6 SUBMISSION RESPONSES – VOLUME D

6.1 D3 – Airspace Architecture (32 of 196 submissions)

Draft EIS/MDP reference: Chapter D3 – Airspace Architecture

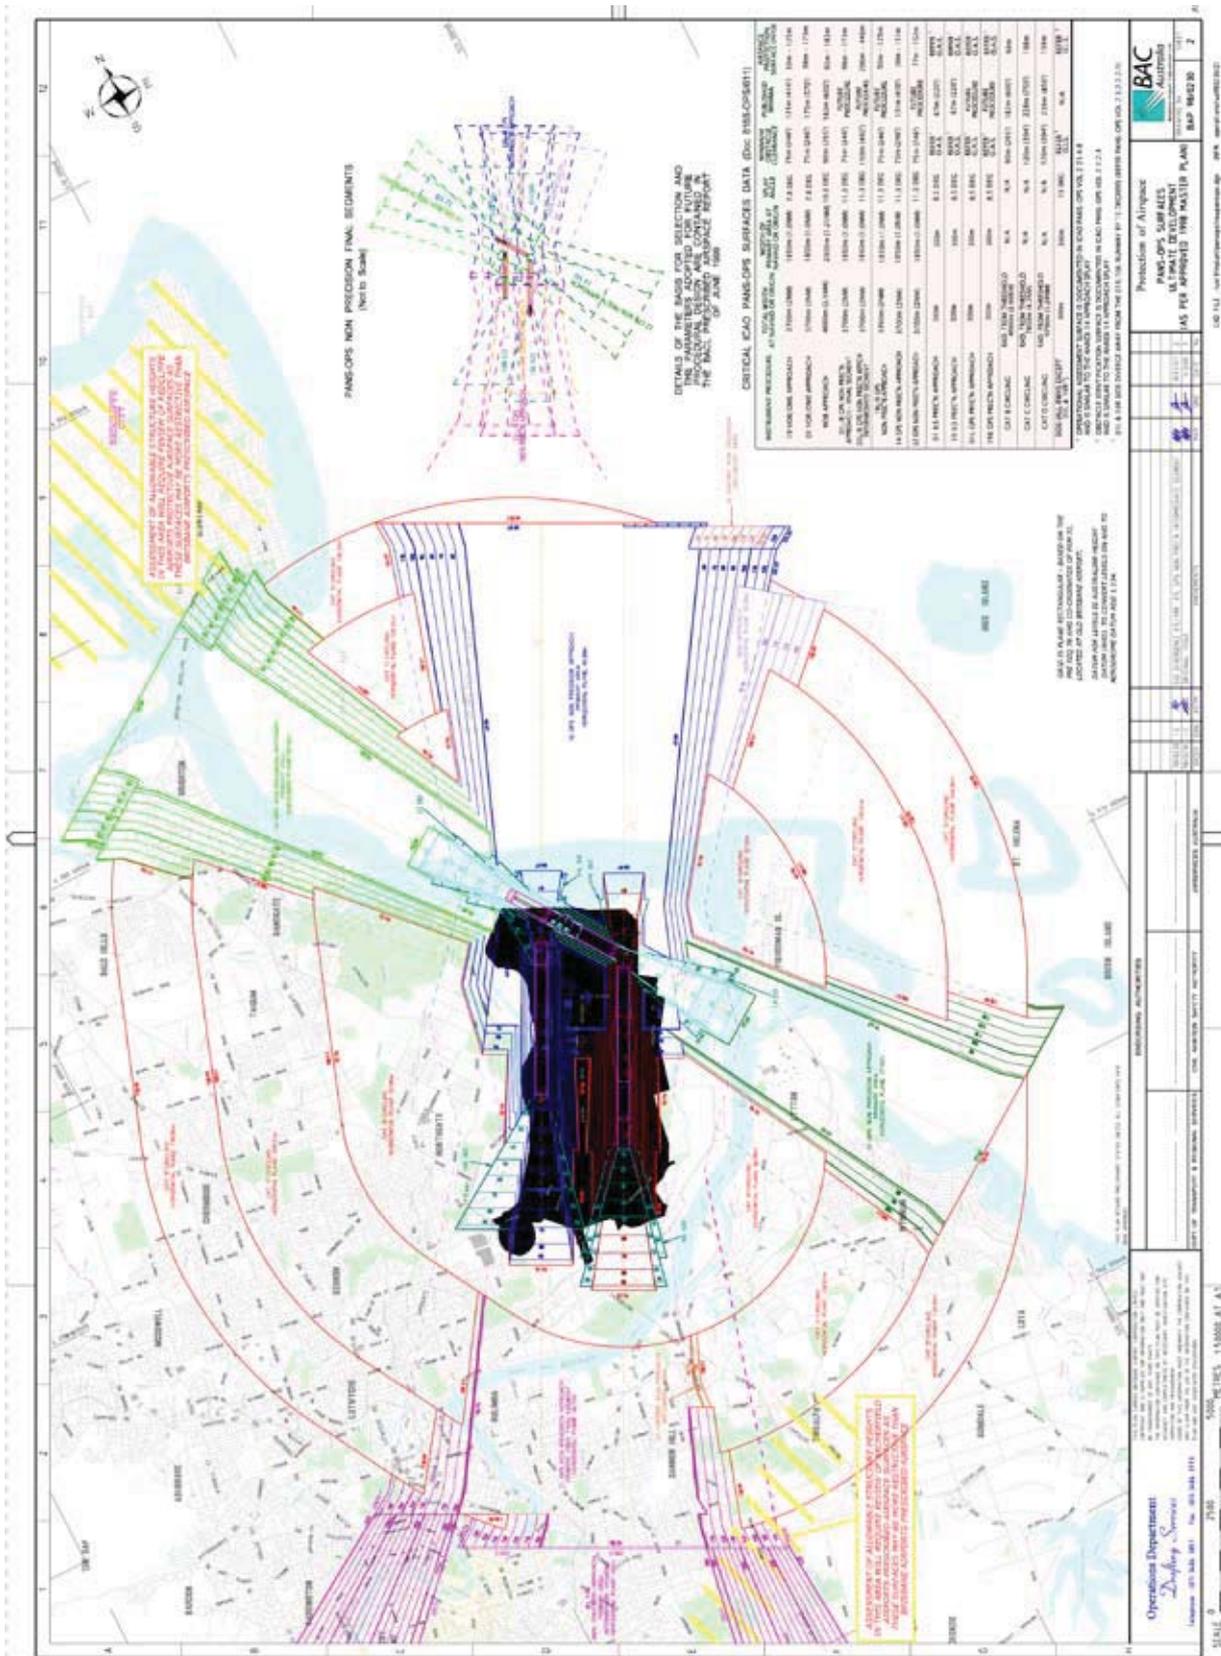
- Recognition of the CBD as a “tall building obstacle zone”;
- Tall building areas in other parts of Brisbane; and
- Clarification of EIS Volume D, Figure 8.3 (Prescribed Airspace).

Figure 8.3 in Volume D of the Draft EIS/MDP represents the PANS-OPS surfaces for the proposed NPR system. It is the same as Figure 14.2 of the approved 2003 Master Plan (page 213) except it has been updated to reflect the retained length of runway 14/32 on airport land. As the representation of these surfaces can be extremely technical the Draft EIS/MDP figure has been presented in the same stylised format as for most general public publications which do not show all possible surfaces at all possible heights and locations.

In the interests of greater technical detail Figure 8.3 in Volume D of the Draft EIS/MDP will be replaced with Schedules A and B, OLS and PANS-OPS drawings respectively, to the declaration of prescribed airspace for Brisbane Airport which was declared on 5 July 2001 under the Airports (Protection of Airspace) Regulations 1996.

Delete Figure 8.3 and replace with:
